Approved Section 4.55 (.....2.....) Modification Application

Project
BARANGAROO STAGE 1B
PUBLIC DOMAIN
Modification S4.55

Drawing Title
WATERMANS QUAY
DETAIL PLAN - TREES

Drawing Title
**HICKSON PARK EAST ENTRY
DETAIL PLAN - NO TREES**

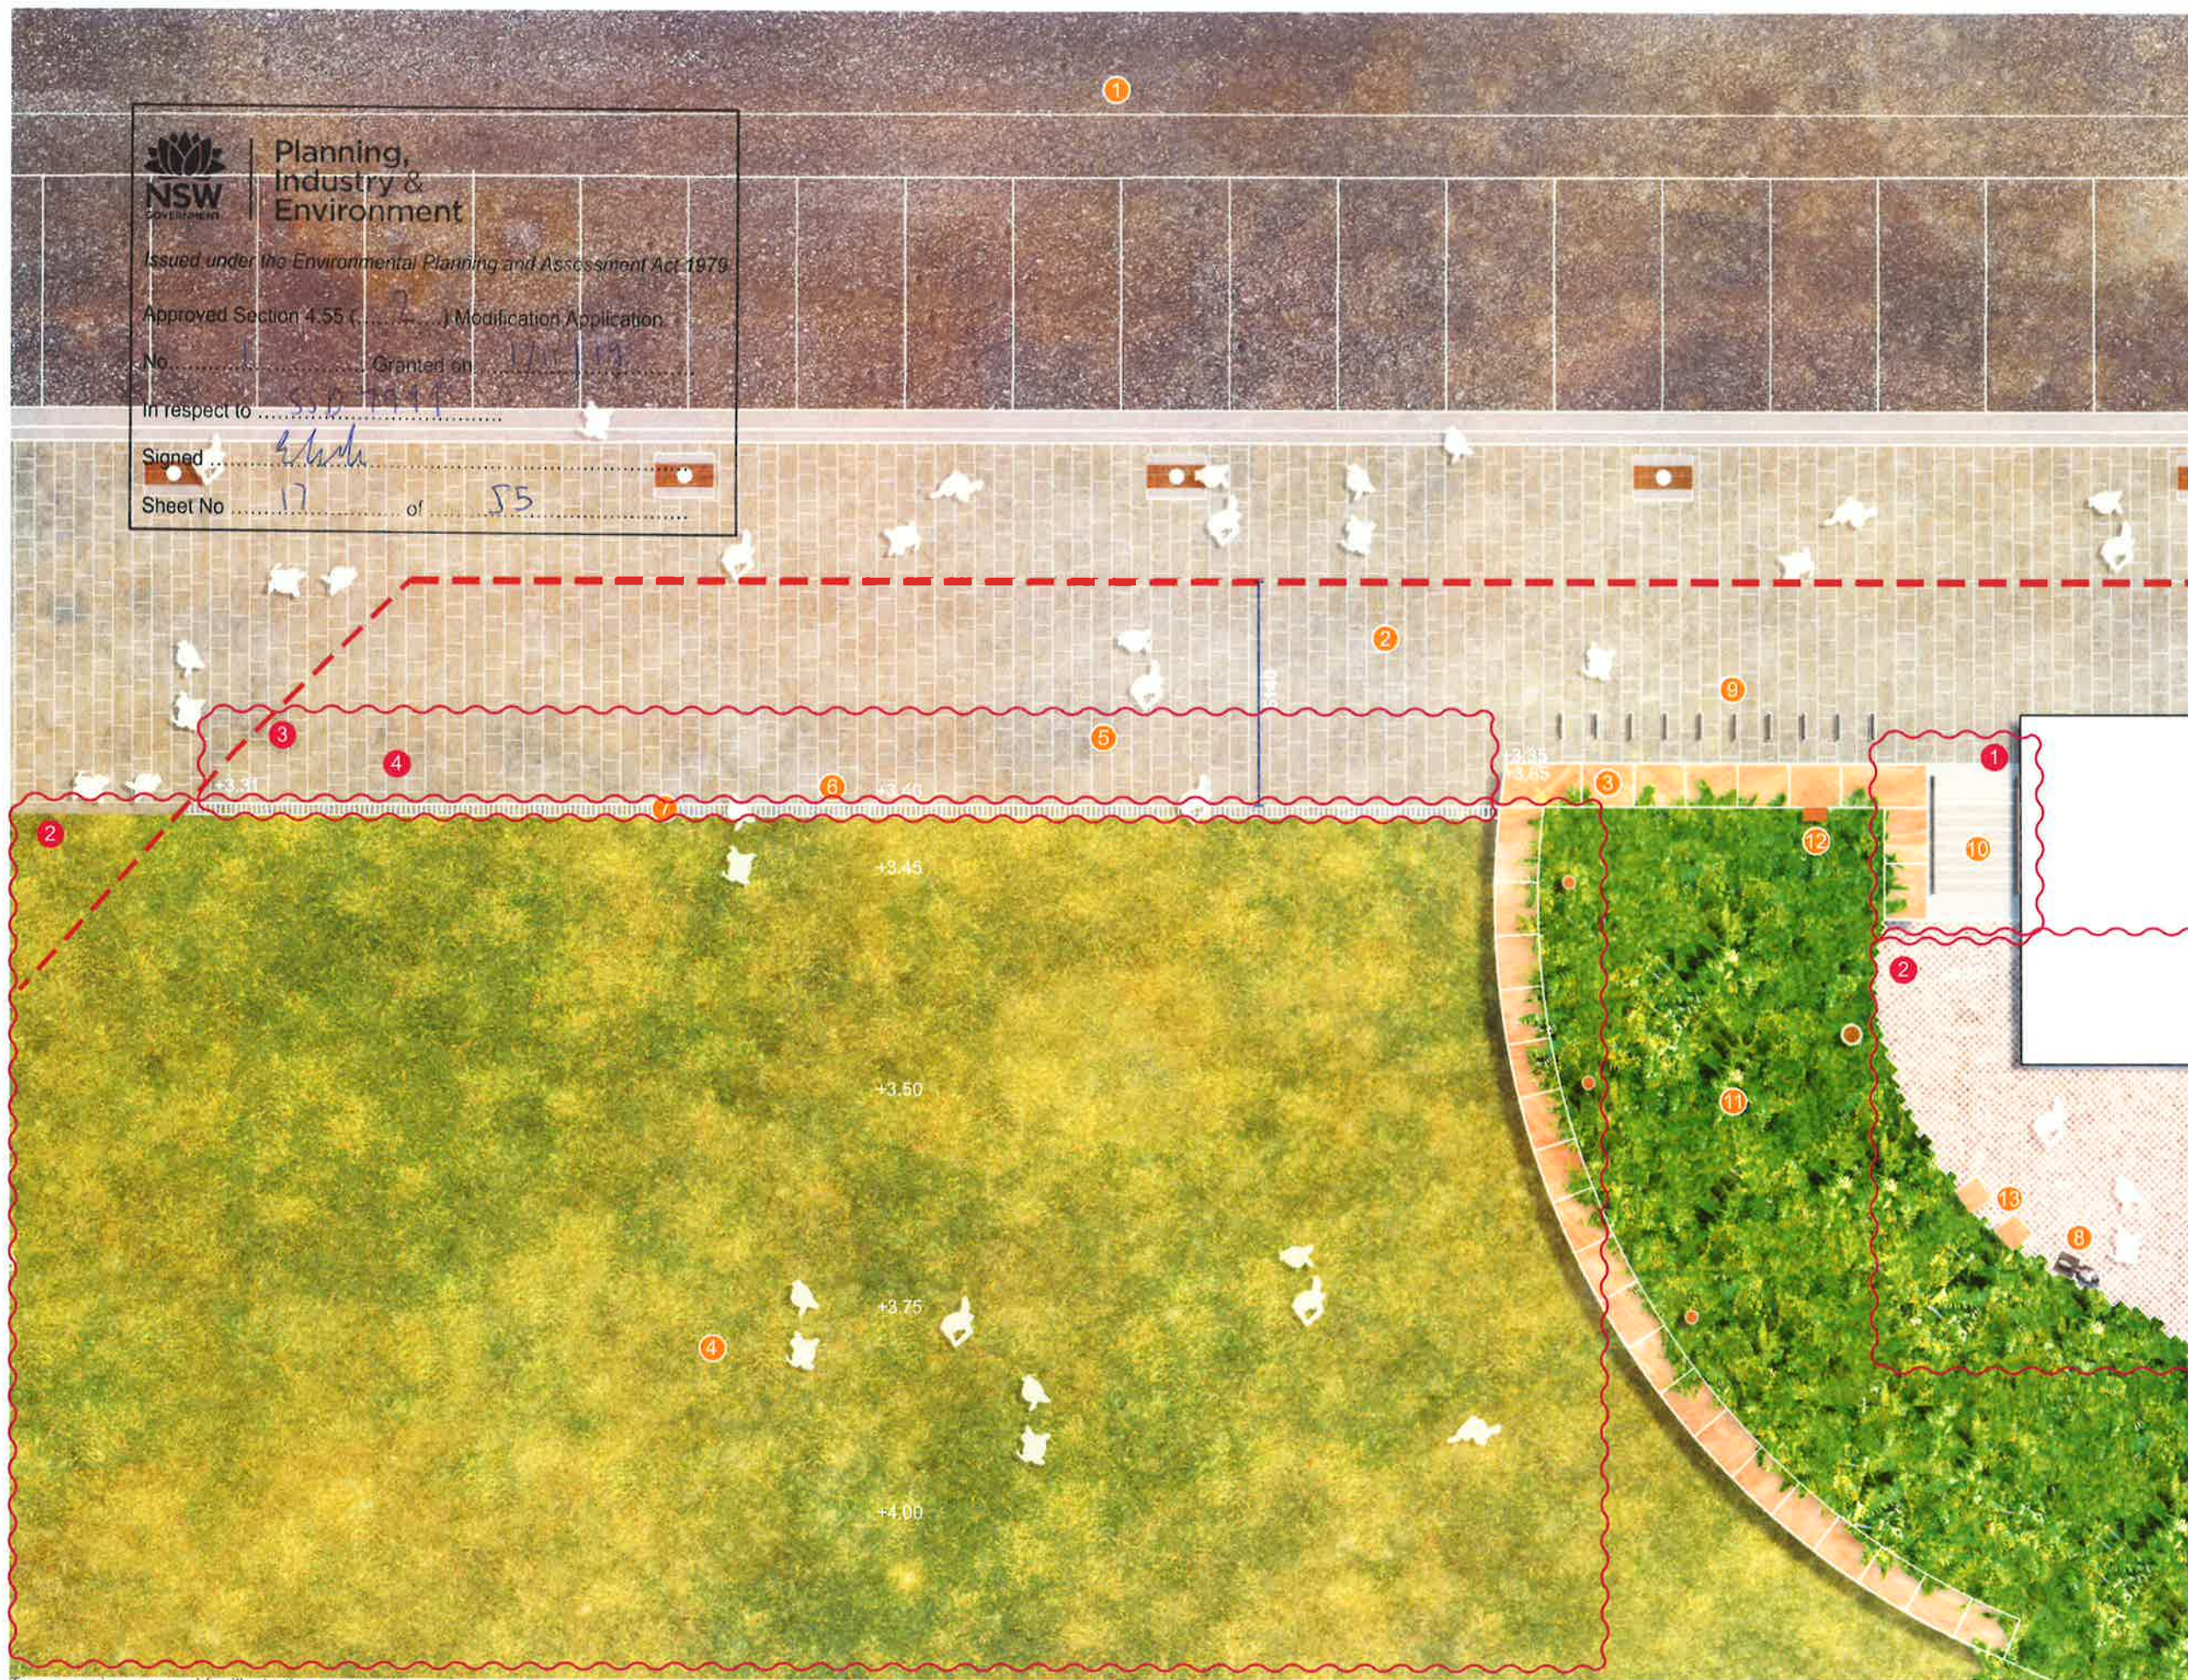
- Amendment cloud
- 1 Increase planting area within the park, change of geometry
- 2 Stone stairs changed to concrete
- 3 Remove porphyry paving to City of Sydney transition as per consent requirement B23
- 4 Shallower ramp, remove handrail, landing, and tactile due to proposed Hickson Road levels
- 5 Remove ramp and sandstone wall due to proposed Hickson Road levels

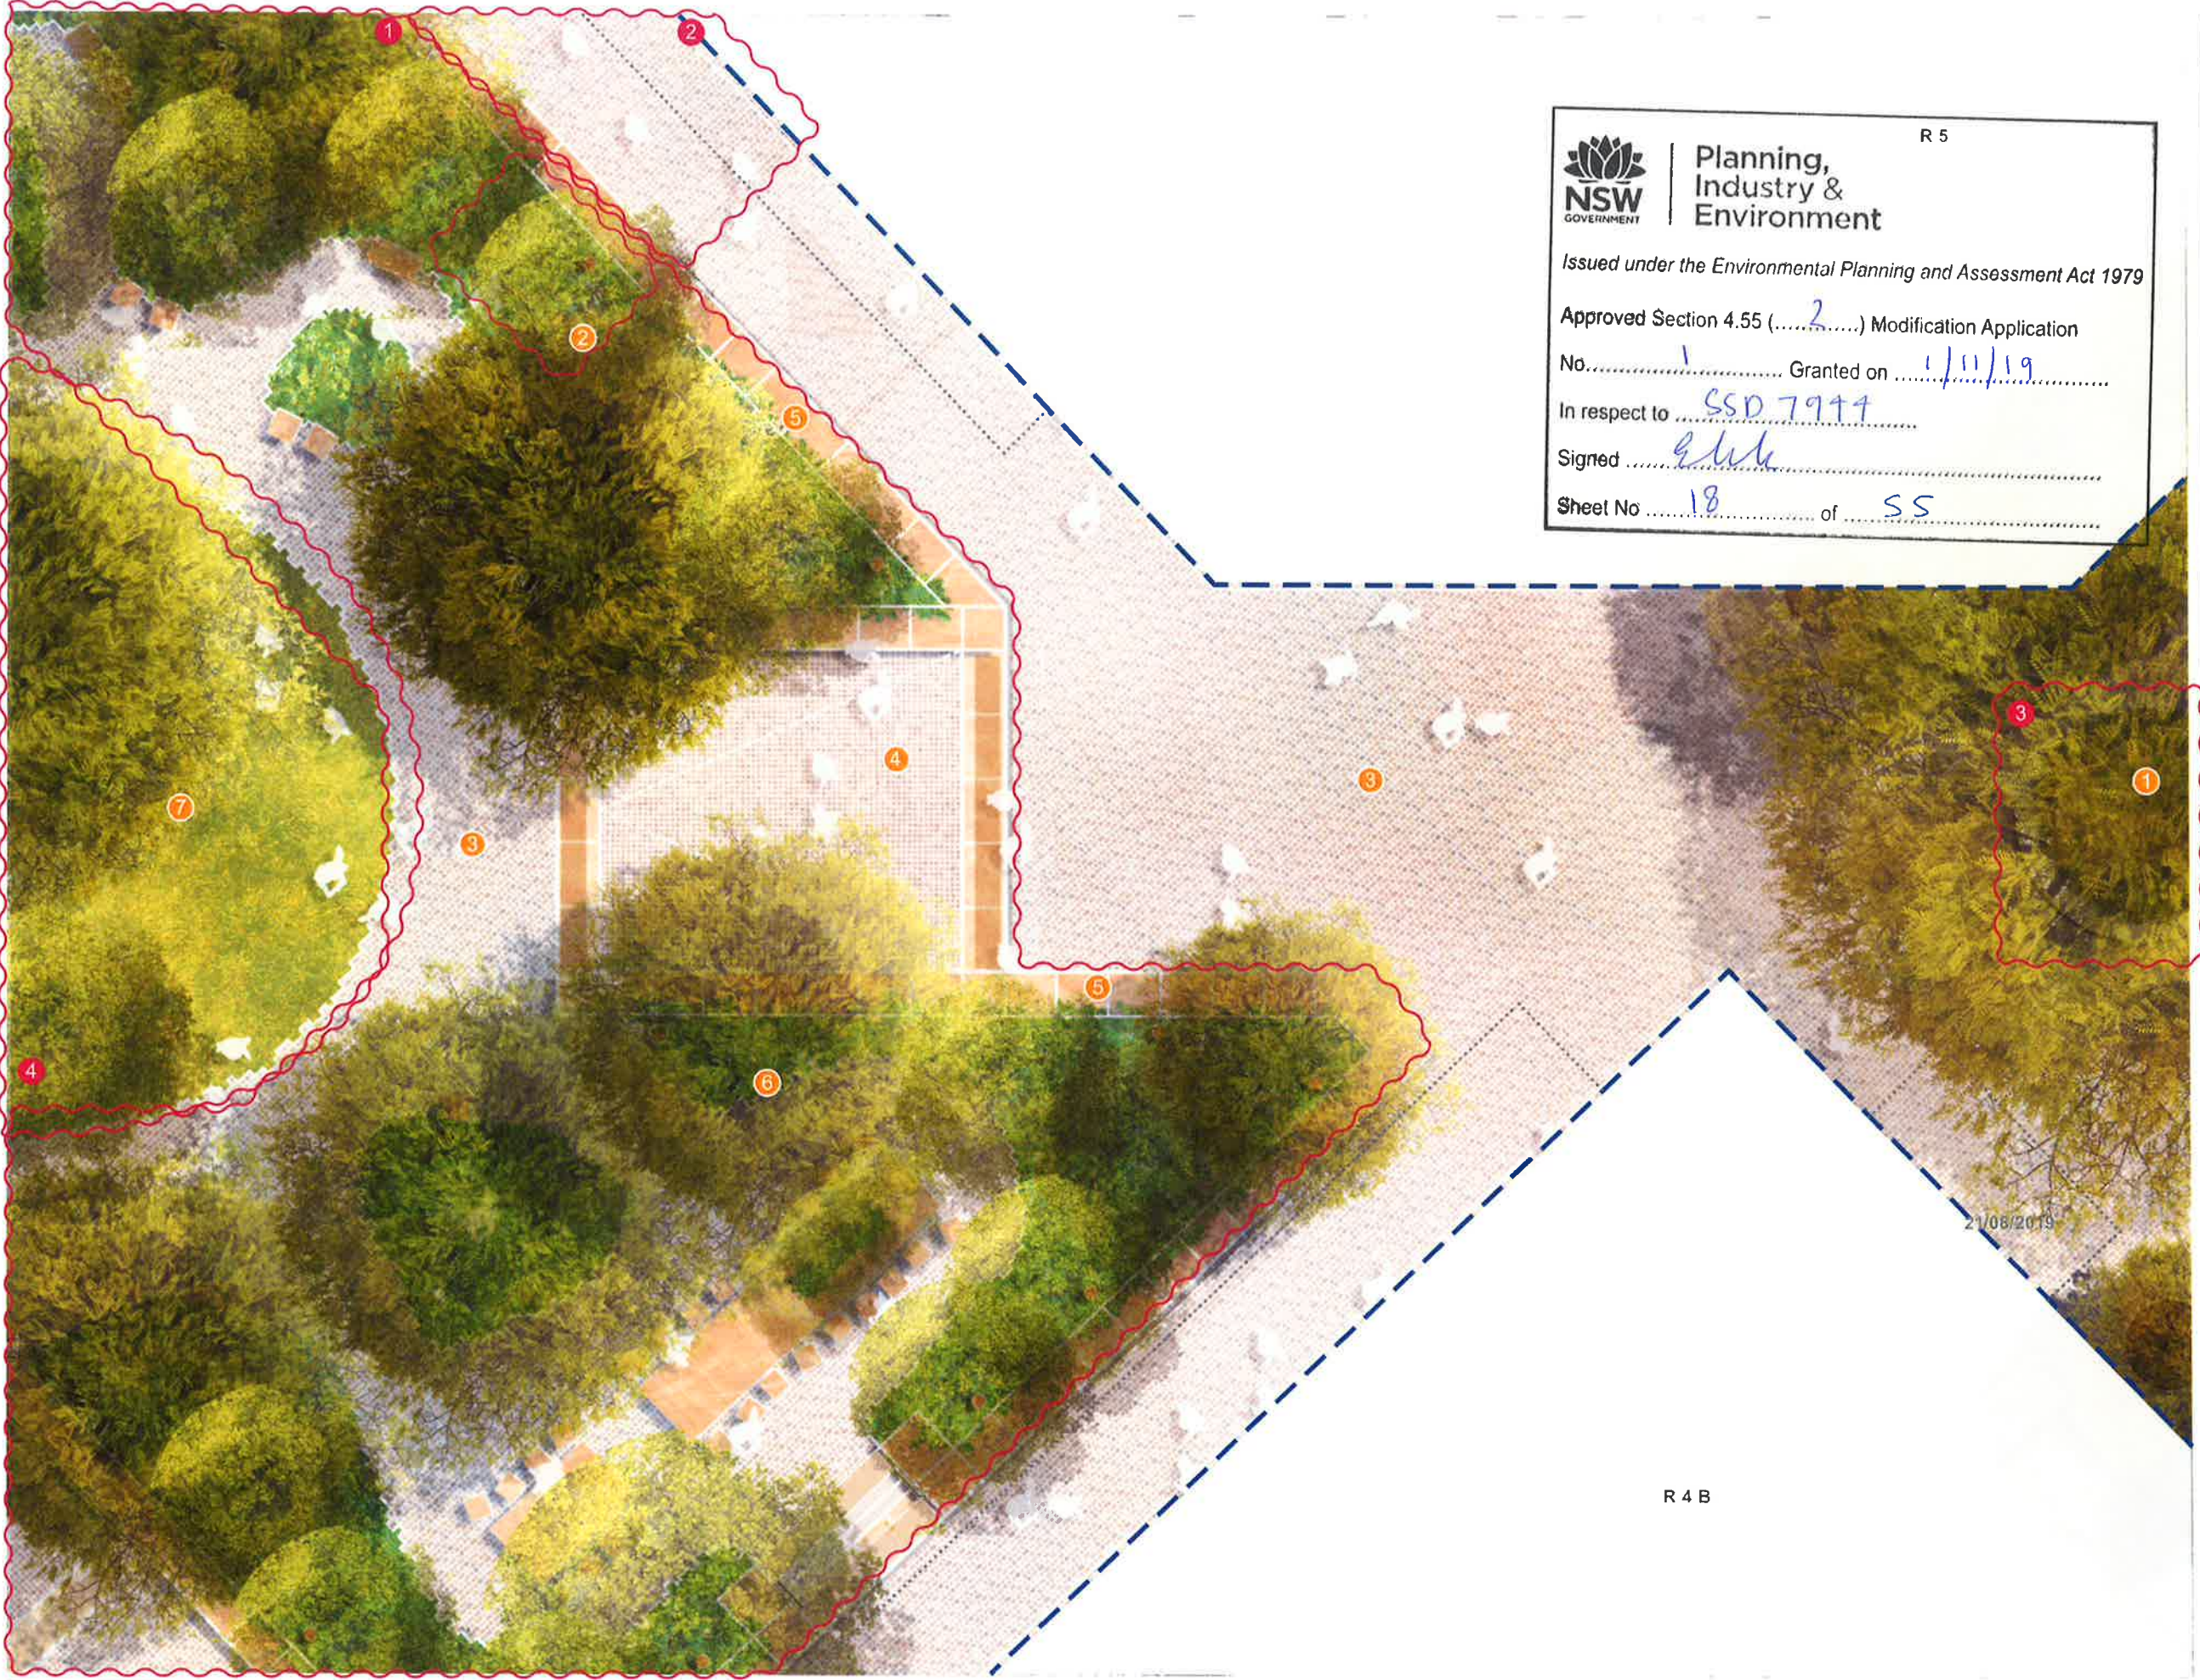
- Amendment cloud
- 1 Stone stairs changed to concrete
- 2 Levels changed due to proposed Hickson Road levels
- 3 Sandstone paving strip changed to City of Sydney paving along Hickson Park
- 4 Delete bollards to East park edge
